SYDNEY WESTERN CITY PLANNING PANEL COUNCIL ASSESSMENT REPORT

Panel Reference	2016SYW221
DA Number	DA-972/2016
LGA	Liverpool City Council
Proposed Development	Demolition of existing structures and construction of an eight storey residential flat building comprising of 101 apartments over two levels of basement parking with associated landscaping and ancillary site works. Liverpool City Council is the consent authority and the Sydney Western CityPlanning Panel has the function of determining the application.
Street Address	9 – 13 Goulburn Street, Warwick Farm (Lot 202 DP 1025972 and Lots 11 and 12 DP 35110)
Applicant	Ventus Group Pty. Ltd.
Land Owner	SMY Investments Pty. Ltd.
Date of DA Lodgement	18 October 2016
Number of Submissions	Nil
Recommendation	Approval
Regional Development Criteria (Schedule 4A of the Act)	The development has a CIV of \$23,893,032
List of all relevant s79C(1)(a) matters	• <i>List all of the relevant environmental planning instruments: s79C(1)(a)(i)</i> - State Environmental Planning Policy No.65 – Design Quality of Residential Apartment Development. - State Environmental Planning Policy No.55 – Remediation of Land. - State Environmental Planning Policy (Bui

Figure 13: Building Separation Northern elevation

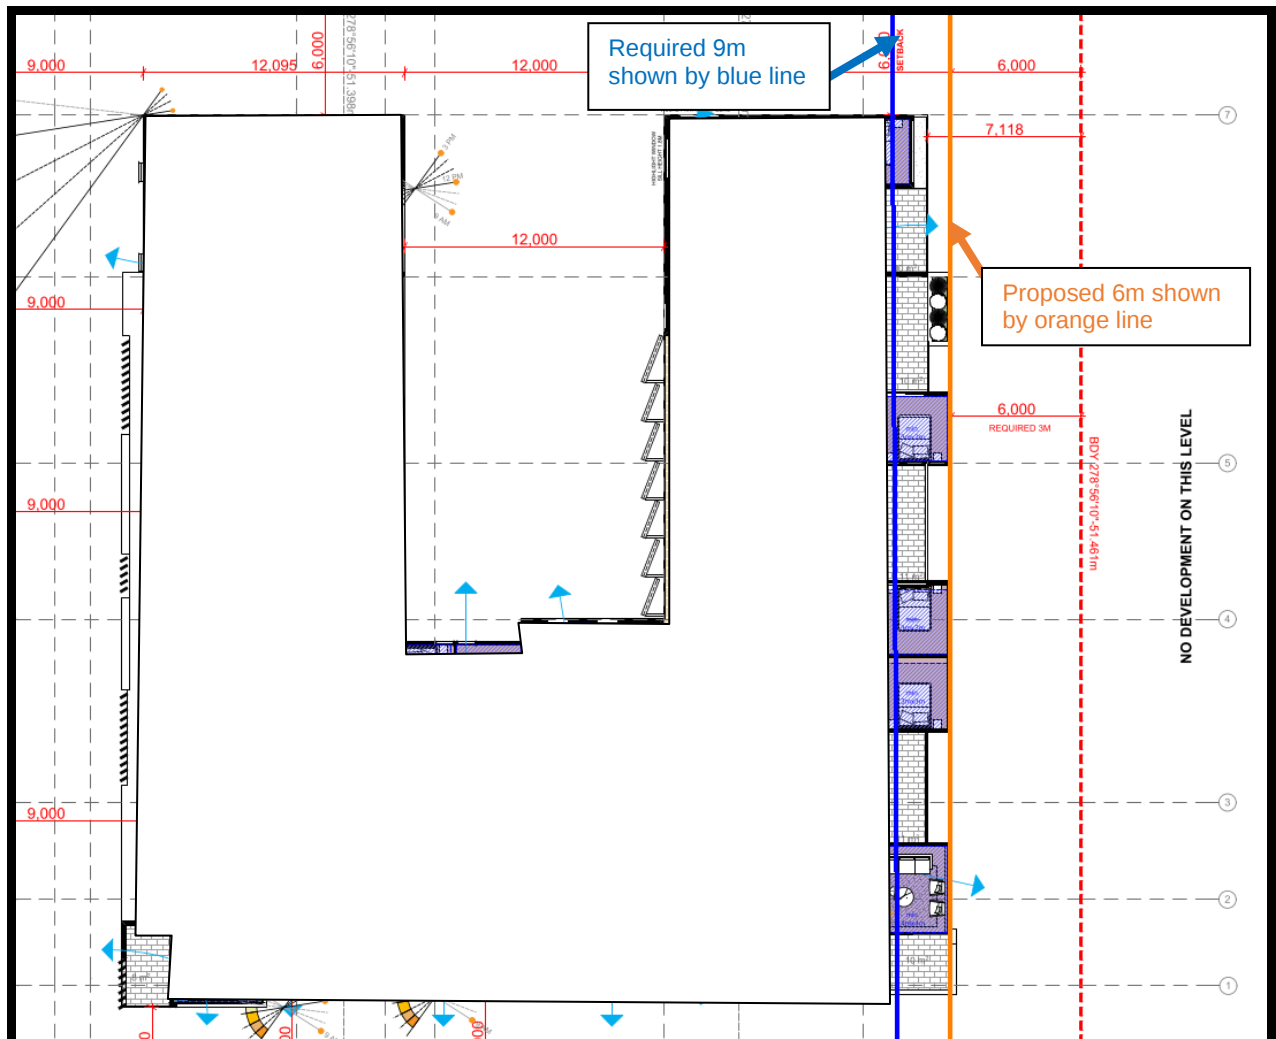
Proposed: From the 5th to the 8th storey the proposal provides a setback from habitable rooms/balconies to the northern boundary ranging from 6m to 7.118m. This represents a non-compliance ranging from 1.88m-3m (21%-33%)

The portions of the building where the non-compliance is generated is detailed in the figure below.

The variation to Section 2F and 3F is worthy of support in this instance for the following reasons;

Figure 14: Building Separation Southern elevation

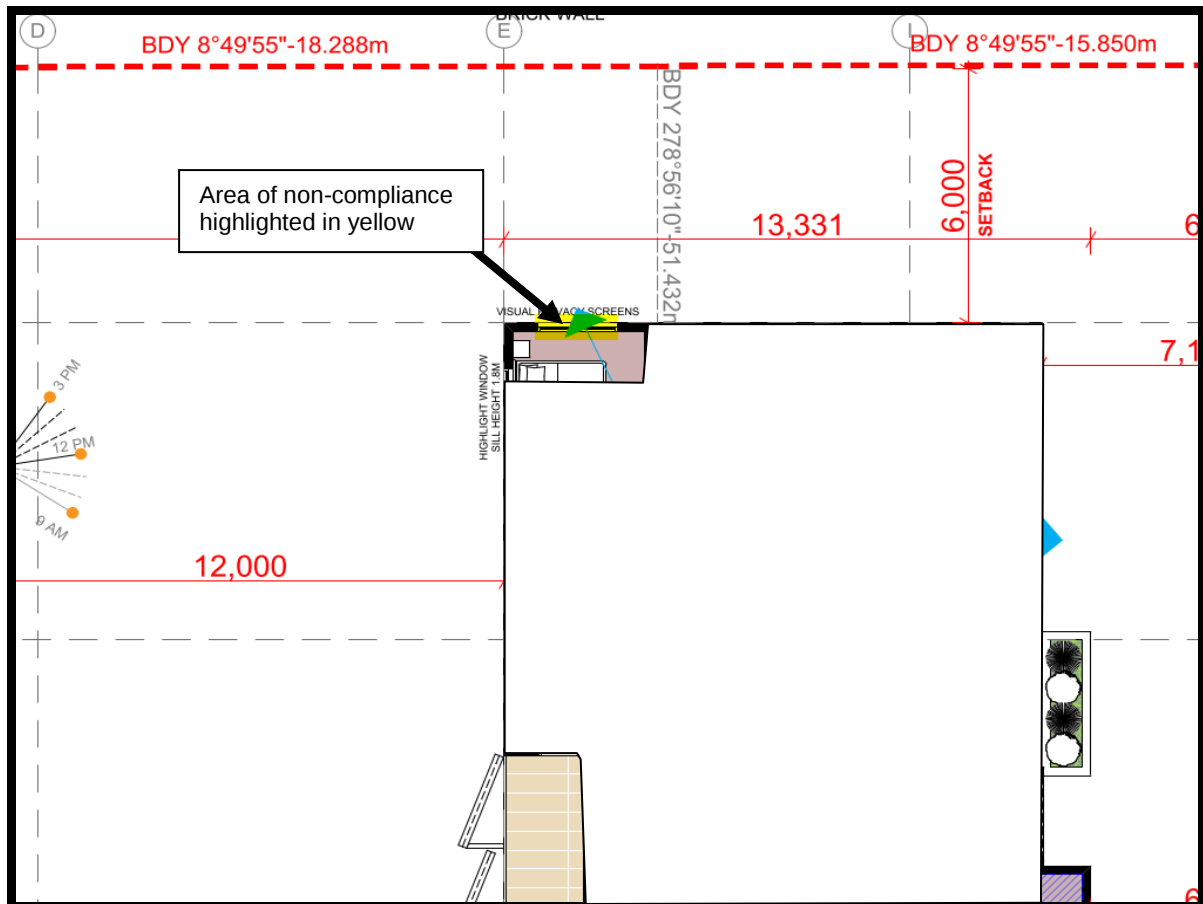
There are no buildings that adjoin the site to the west that exceed a height of 5 storeys. As such from the 6th to the 8th storey a setback of 9m to the western boundary for the northern wing of the building should be incorporated. However a setback of 6m is proposed instead of 9m representing a variation of 3m or 33%.

The section of the building where the non-compliance is generated is detailed in the figure below.

The variation to Section 2F and 3F is worthy of support in this instance for the following reasons;

- 4) The bedrooms in question where the non-compliance is generated propose 2 windows, one of which faces west and another along the southern elevation of the northern wing of the building. To enforce strict compliance, the windows along the western elevation of the subject bedrooms can be removed, therefore only requiring a setback of 6m. However this approach is not considered necessary as the proposed development has incorporated appropriate privacy measures. The removal of the windows along the western elevation would also result in a reduction in solar access to the bedrooms in question, which is considered an inferior design outcome.

Figure 15: Building Separation Northern elevation

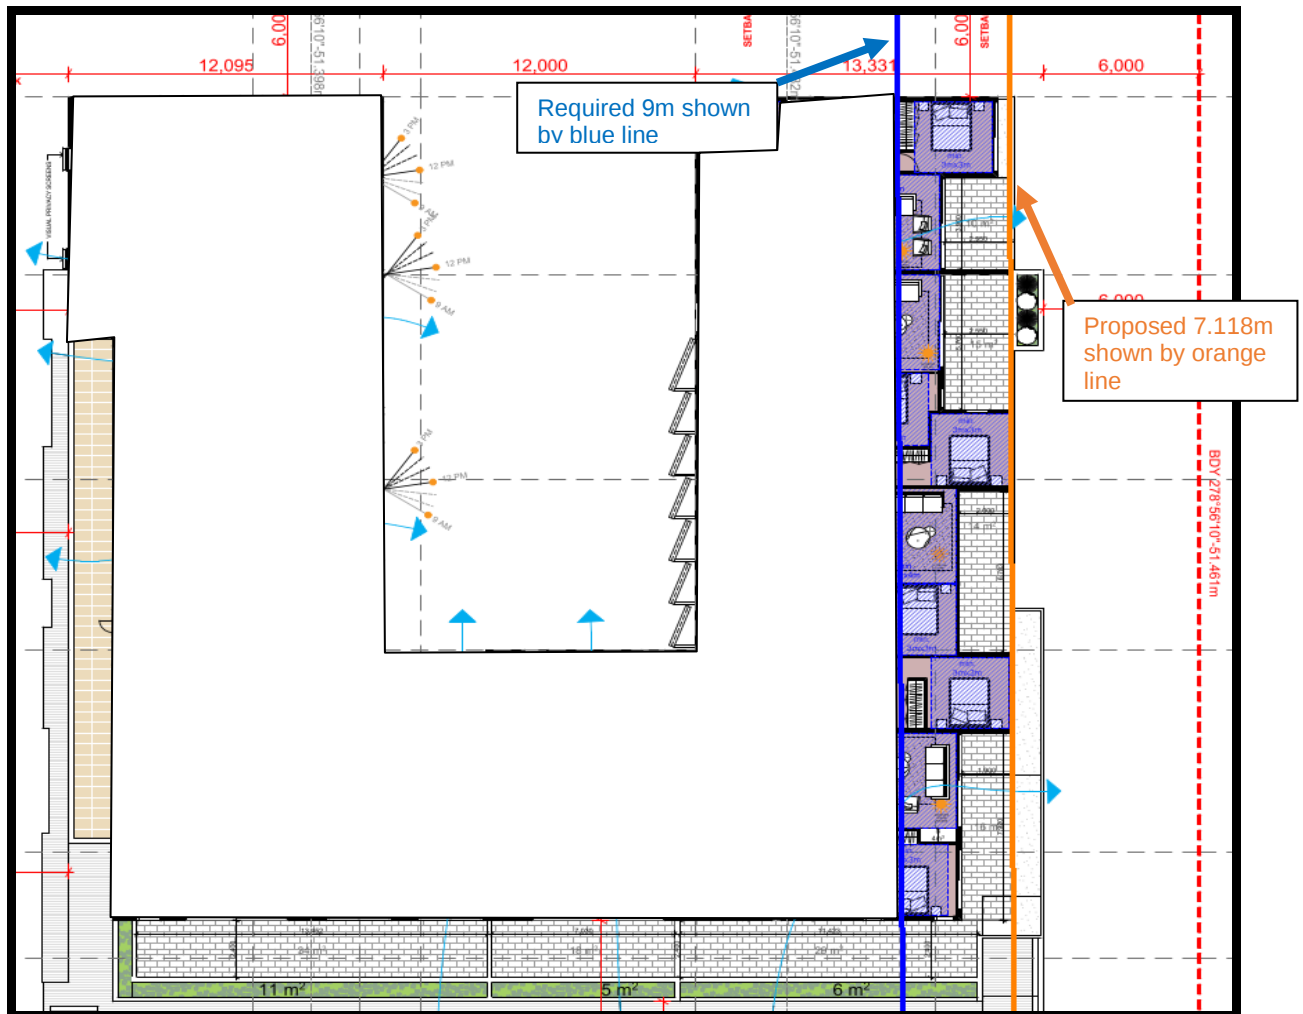
Proposed: At the 9th storey the proposal provides a setback from habitable rooms/balconies to the northern boundary of 7.118m instead of 12m. This represents a non-compliance of 4.88m or 40.6%.

The portions of the building where the non-compliance is generated is detailed in the figure below.

The variation to Section 2F and 3F is worthy of support in this instance for the following reasons;

Figure 16: Building Separation Southern elevation

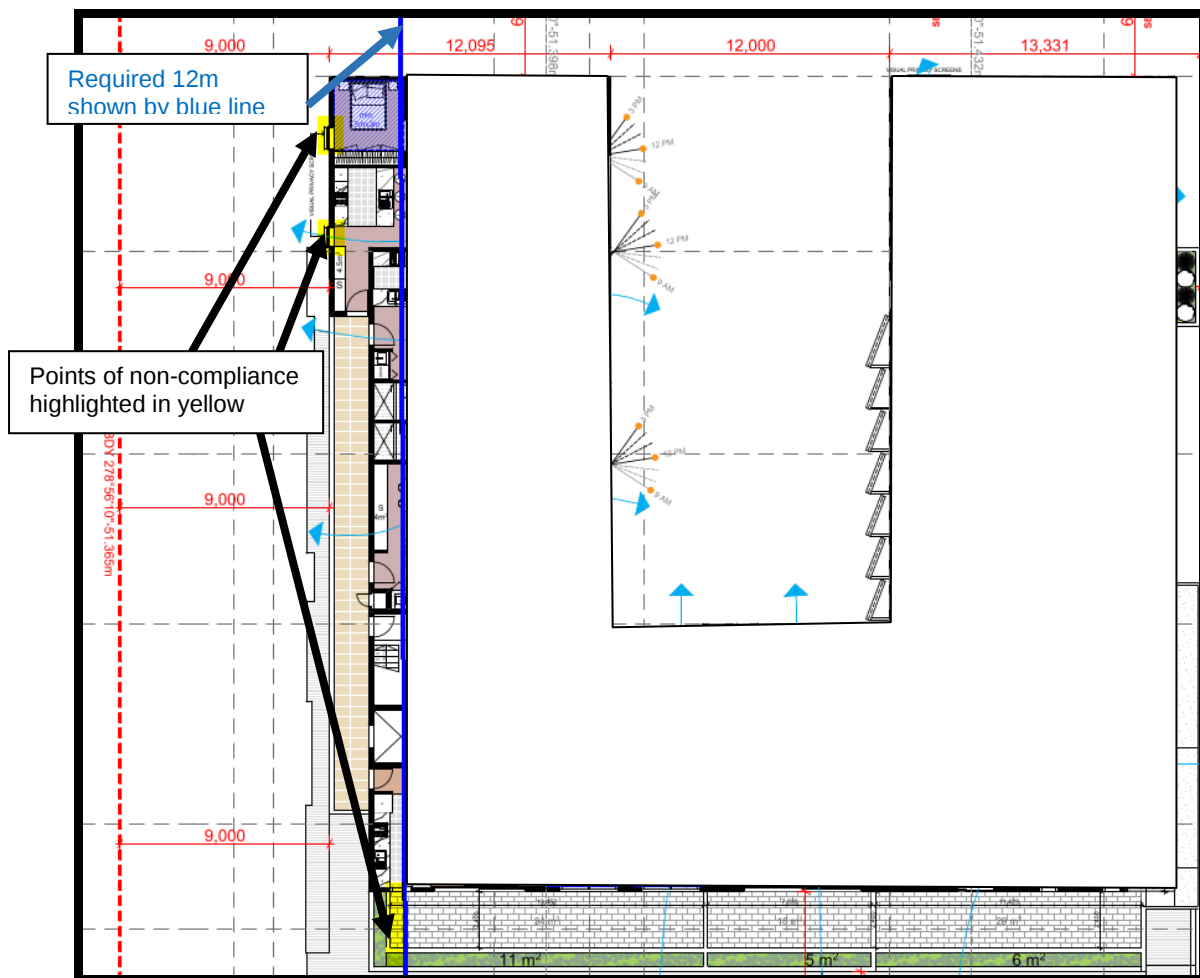
Proposed: At the 9th storey the proposal provides a setback from habitable rooms/balconies to the southern boundary of 9m instead of 12m. This represents a non-compliance of 3m or 25%.

The portions of the building where the non-compliance is generated is detailed in the figure below.

The variation to Section 2F and 3F is worthy of support in this instance for the following reasons;

Figure 17: Building Separation Western elevation

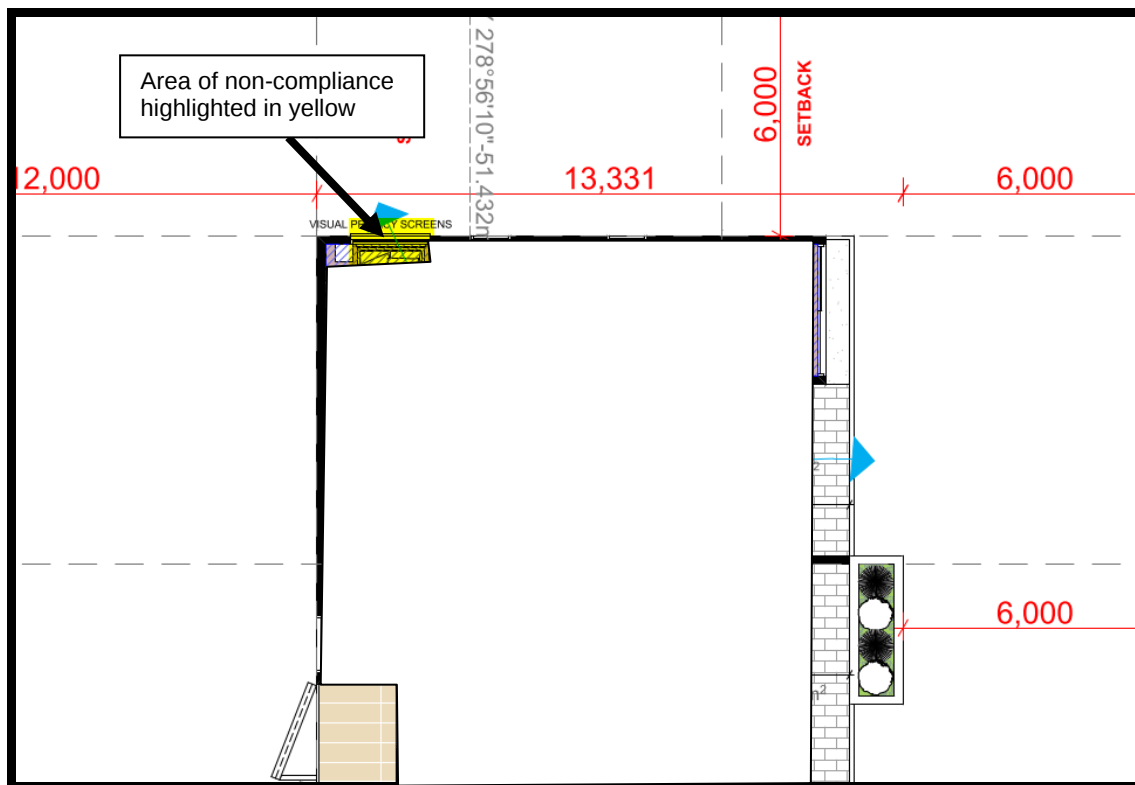
Proposed: At the 9th storey the proposal provides a setback from the habitable bedroom of unit B.8001 of the northern wing of the building to the western boundary of 6m instead of 12m. This represents a non-compliance of 6m or 50%.

The section of the building where the non-compliance is generated is detailed in the figure below.

The variation to Section 2F and 3F is worthy of support in this instance for the following reasons;

Figure 18: Building Separation between wings

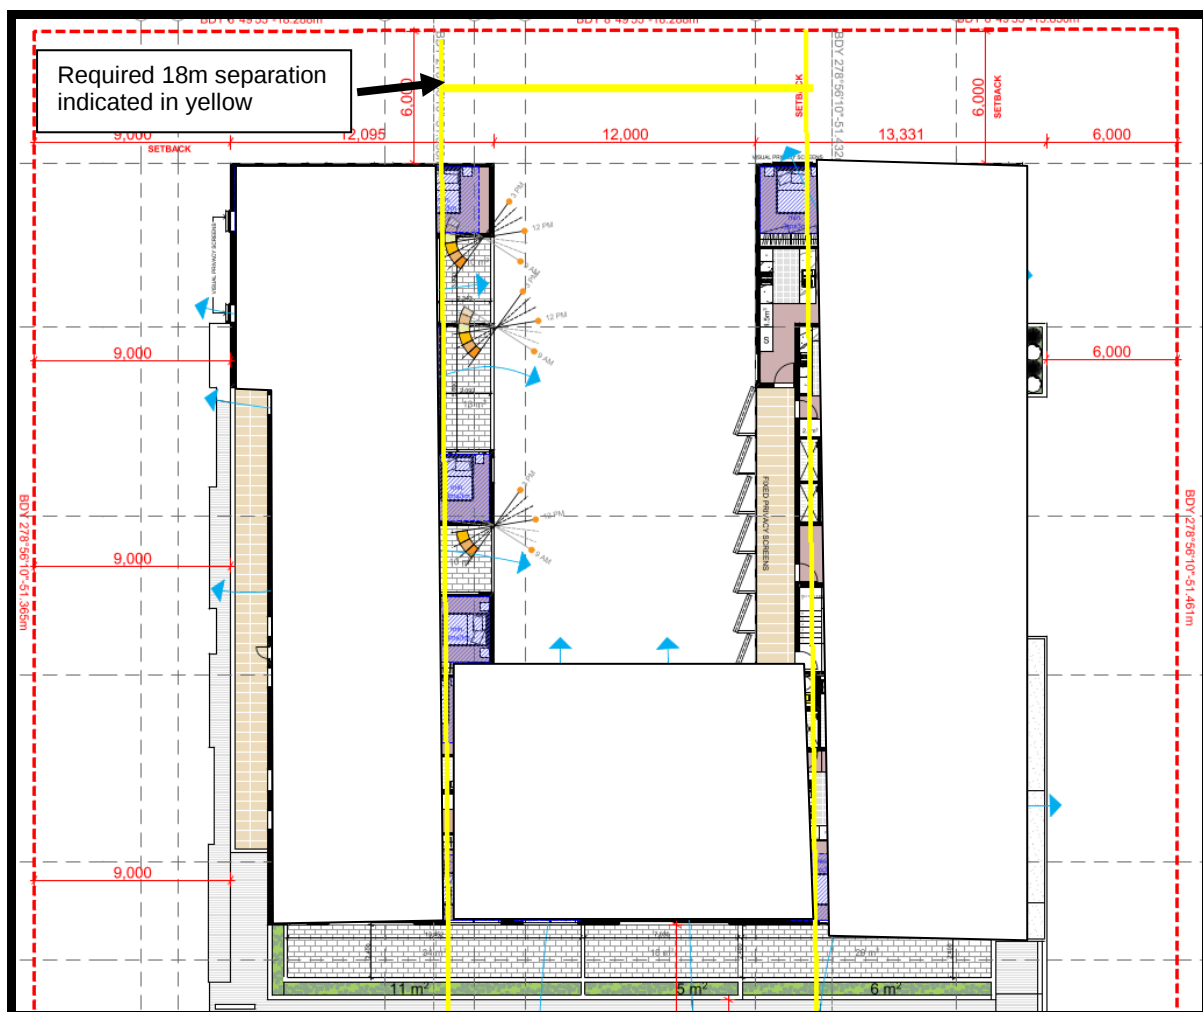
Proposed: At the 9th storey the proposal provides a separation of 12m instead of 18m between the wings of the building. This represents a non-compliance of 6m or 33%.

The section of the building where the non-compliance is generated is detailed in the figure below.

The variation to Section 2F is worthy of support in this instance for the following reasons;
